APPLICATION NO.	FILING DATE	FIRST NAMED INVENTOR	ATTORNEY DOCKET NO.	CONFIRMATION NO.
10/079,990	02/19/2002	Chi Lam Wong	USP1787A-CLW	7105

Office Action Summary	Application No. 10/079,990	Applicant(s) WONG, CHI LAM	
	Examiner CARL D. PRICE	Art Unit 3749

DETAILED ACTION

【圖7】

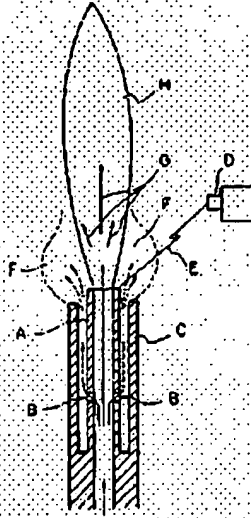
JP '434 shows and discloses (figure 7) a fuel nozzle assembly including a nozzle body having a root opening and root chamber (29, for example), an emitting opening, an air inlet (L), wherein said air inlet is positioned adjacent to said root opening to define an elongated mixing chamber (K) axially extended between the air inlet to the emitting opening. JP '434 shows a combustion housing (F; figure 5) supported around the emitting opening of the nozzle body defining an ignition chamber (see 20) therein; and a single (R), or a plurality (18), of elongated nozzle ducts, each having an ignition end and a root end extending to a ceiling of the root chamber. JP '434 also discloses a torch stabilizing arrangement, in the form of elongated (gear shaped) emitting openings (Q) providing a plurality of root flame (illustrated in figures 6 and 7) portions which form stable root flames for igniting the mixture gas ejected from the ignition ends of the nozzle ducts for stabilizing and holding the spaced flames. JP '434 relies on a having a micro nozzle pore and filter (10, 11, 12) arrangement for vaporizing and delivering liquefied fuel from a valved container to a flame head in a windproof lighter having a combustion chamber and

ignition means. JP '434 includes a casing having a liquid fuel gas storage and a fuel valve which is actuated by a fuel lever pivotally mounted in the casing for releasing fuel there from toward and ignition unit generating sparks. JP '434 however does not disclose a mixing chamber diameter of 1 mm to 2.5 mm, a micro nozzle pore diameter of 0.05 mm to 0.12 mm, a "mesh" filter, and the duct spacing as set forth in applicant's claims.
